**DECISION NOTICE FOR OPERATIONAL WORKS**  
**(CONSTRUCTION OF NEW SECTION OF A DRIVEWAY) LOT 16 ON RP745096 -**  
**18R OCEAN VIEW ROAD – KILLALOE**

**DECISION NOTICE FOR OPERATIONAL WORKS**  
**(CONSTRUCTION OF NEW SECTION OF A DRIVEWAY) LOT 16 ON RP745096 -**  
**18R OCEAN VIEW ROAD – KILLALOE**

Operational Works (Engineering) Roadworks, Earthworks, Concrete Works, Erosion and Sediment Control, Drainage Works, and Clearing of Vegetation; excluding Landscape and Lighting Works

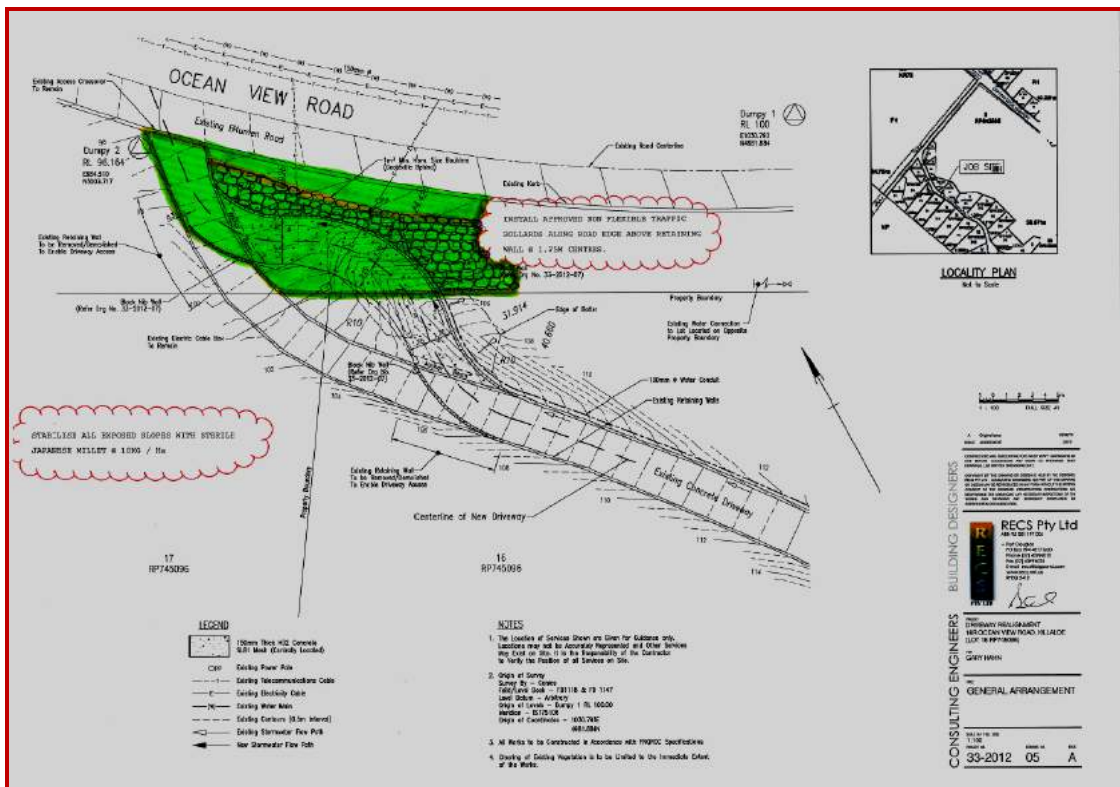
- e. The proposed access driveway as shown on RECS Pty Ltd drawing 33-2012-06 Rev (A) is to be limited to a maximum vertical grade of 27%.
- f. The proposed Non Flexible Traffic Bollards on the road edge are to be located along the Council Road Reserve Area affected by the works, as indicated above.

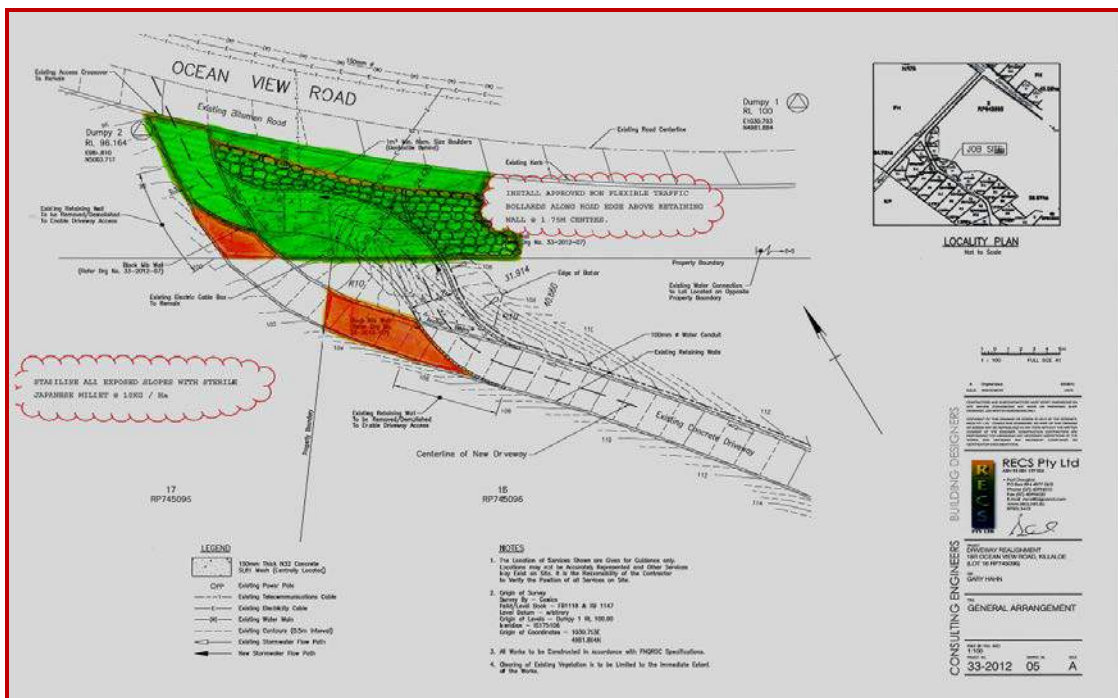
- a. The existing concrete driveway sections located on the Council Road Reserve and Lot 16 on RP745096, that are to be redundant (as shown below – orange areas) are to be demolished and removed and then these two areas revegetated.
